Change Order No. 5  
Purchase Order 6191  
P12765  
Prospect Lake Clean Water Center  
Prospect Lake Water, L.P.

RE: Prospect Lake Clean Water Center Project – City-Initiated Change

**Scope Change Order Proposal**  
**Feedstock Water Temperature Analysis**

## Prospect Lake Feedstock Water Temperature Analysis

**Figure 1.** Individual Well Temperature Data at Start-up and After 30 – 60 Minutes of Operation

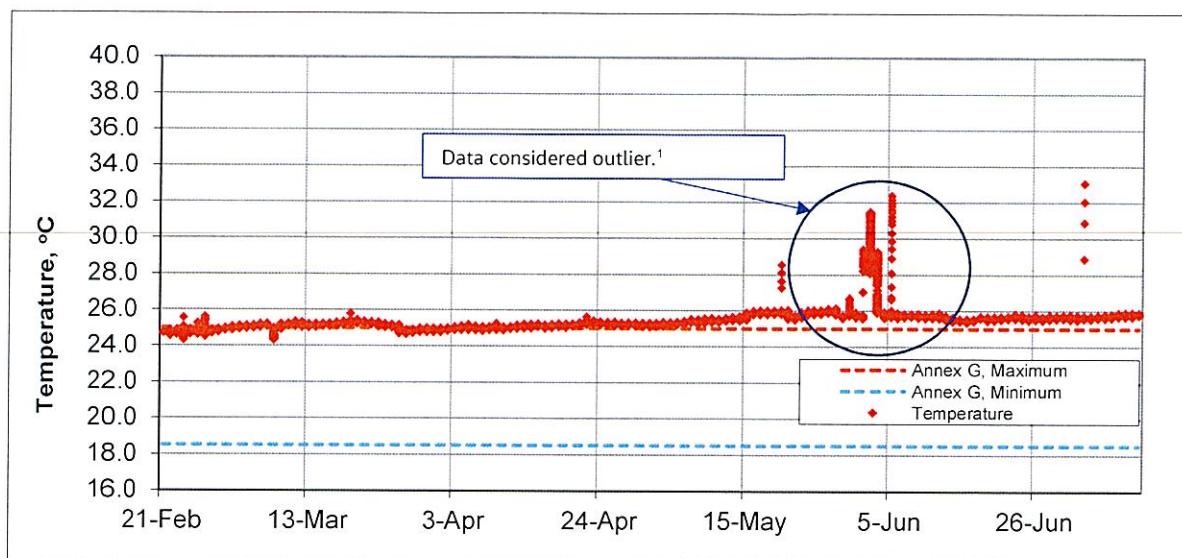
As shown in Figure 1, the raw water temperature varied slightly across the wellfield. The temperature ranged from 23.8 to 26.9 °C. Table 1 below shows the water quality temperature data distribution. The 90<sup>th</sup> percentile at start-up was 26.8 °C while the 10<sup>th</sup> percentile was at 25.7 °C, exceeding Annex G limits.

- Prospect Lake Water, L.P. should consider amending Annex G of the Comprehensive Agreement to a new revised range of 23 – 28 °C with an average temperature value set at 26 °C. This change will allow the City to be compliant with the feedstock water requirements and maintain a margin of safety, should future groundwater temperatures at Prospect Wellfield change.
- Prospect Lake Water, L.P. should consider whether the change in the temperature specification impacts the new facility's operational performance, including chemical and energy consumption guarantees, equipment and maintenance warranties, and any changes to the product water specifications as listed in Annex H-2 of the Comprehensive Agreement, as per RFP #14.
